Subject: Dresden Nuclear Power Station, Unit 3  
Weld Overlay on RWCU Non-Regenerative Heat Exchanger 3-1204AB  
Tubeside Inlet Nozzle.  
NRC Docket No. 50-249

**ComEd Response to  
NRC's REQUEST FOR ADDITIONAL INFORMATION  
CONCERNING THE REACTOR WATER CLEANUP SYSTEM HEAT  
EXCHANGER REPAIR**

**COMMONWEALTH EDISON COMPANY  
DRESDEN NUCLEAR POWER STATION, UNIT 3  
DOCKET NO. 50-249**

Figure 2  
As Measured Overlay Dimensions

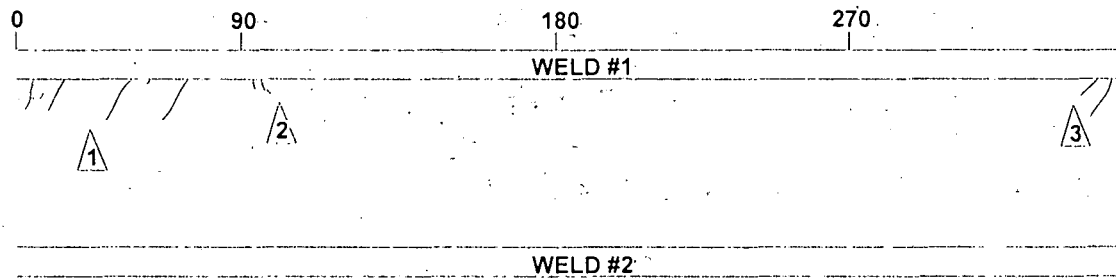
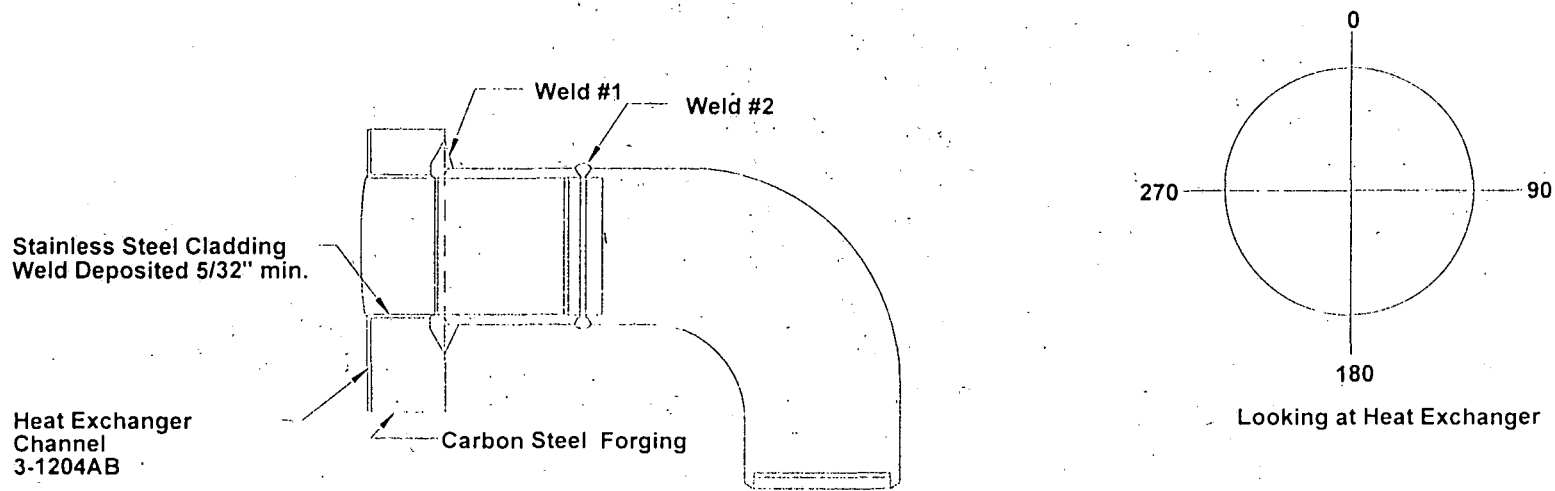
2. Provide the as-measured weld overlay dimensions.

Response: The as-measured weld overlay dimensions are provided in Figure No. 2.

**Figure 1**  
**Through Wall Indications on 3-1204-AB Inlet Nozzle**

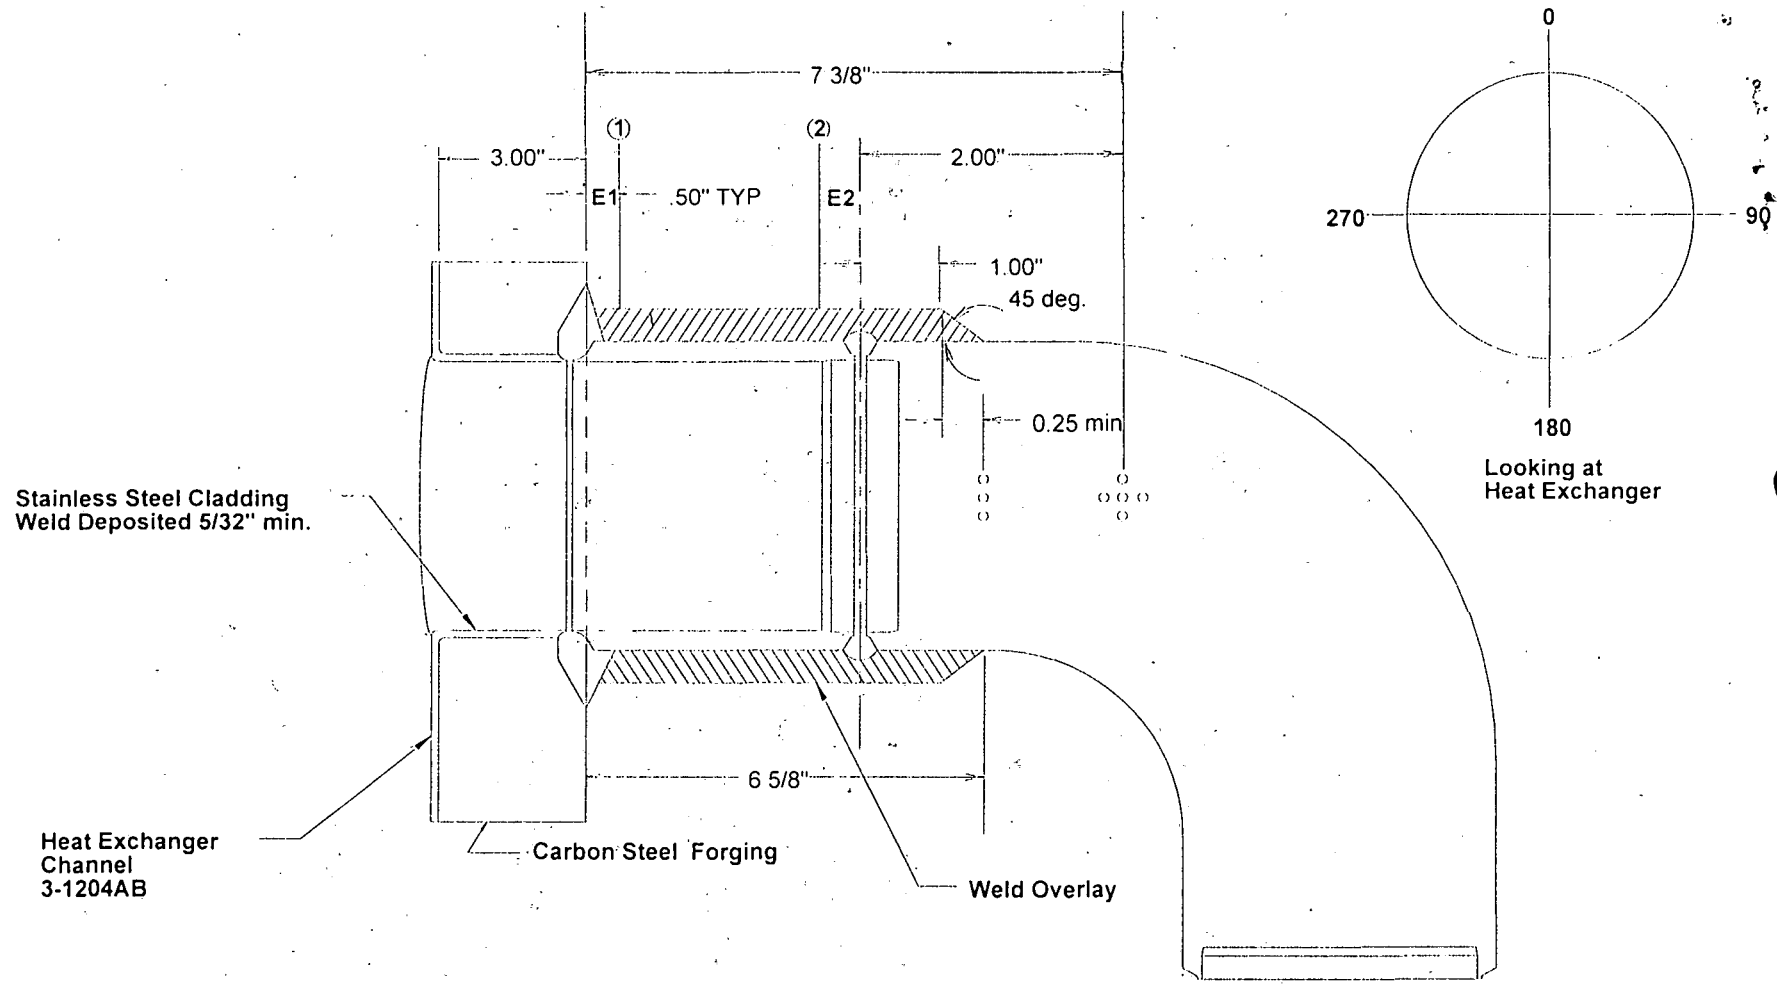
1. Provide a description of the flaw, including the size, location and a sketch of the exact location of the flaw.

Response: The attached Figure No. 1 contains a map and description of the flaws. The two indications closest to 0° in area 1 of this report are believed to be the throughwall flaws. Positive identification of throughwall flaws was not made since the flaws were not excavated.

- ① 5 linear indications ranging in size from 1/8" to 1". Indications extend from the toe of the weld on the pipe side.
- ② 2 linear indications ranging in size from 1/4" to 5/8". Indications extend from the toe of the weld on the pipe side.
- ③ 2 linear indications ranging in size from 3/16" to 3/4". Indications extend from the toe of the weld on the pipe side at approximately 350 degrees.
